ACCESSION NBR: 8002060441 DOC. DATE: 80/01/31 NOTARIZED: NO DOCKET #
 FACIL: 50-269 Oconee Nuclear Station, Unit 1, Duke Power Co. 05000269
 50-270 Oconee Nuclear Station, Unit 2, Duke Power Co. 05000270
 50-287 Oconee Nuclear Station, Unit 3, Duke Power Co. 05000287

SUBJECT: Forwards response to NRC 791212 questions & 800111 telcon re degraded grid voltage.

OCONEE NUCLEAR STATION

NRC Request for Information
Degraded Grid Voltage

Figure 1

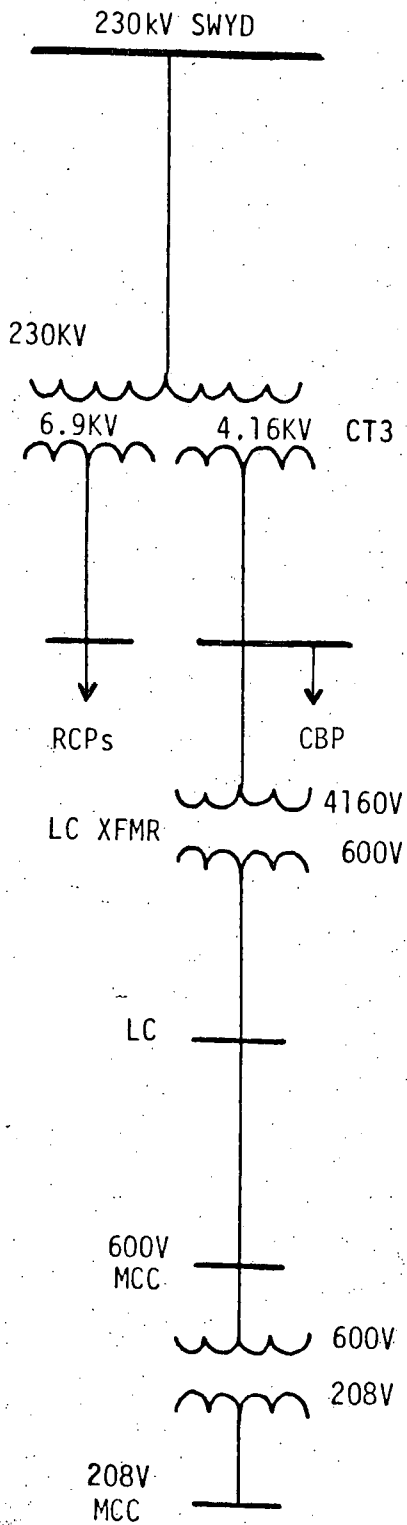
8. In the January 11, 1980 telecon between Duke and NRC, the NRC asked that Duke respond to Item 3 of their Guidelines for Voltage Drop Calculations.
3. All actions the electric power system is designed to automatically initiate should be assumed to occur as designed (e.g., automatic bulk or sequential loading or automatic transfers of bulk loads from one transformer to another). Included should be consideration of starting of large non-safety loads (e.g., condensate pumps).

Position 3 of the NRC Guidelines for Voltage Drop Calculations states that the voltage analysis should consider the starting of a large non safety-related motor at a time following the transfer of all normally running loads to the startup transformer and the starting of all required ES loads (i.e., after steady-state conditions have been established on the power distribution system).

An analysis has been performed considering the starting and running of a 2000 HP Condensate Booster Pump under the conditions described above. The analysis shows that the non-safety-related pump will start and that its starting has no adverse effects on the already running loads. Figures 1 and 2 provide the voltage profiles for starting and running the Condensate Booster Pump in addition to the previously analyzed loads.
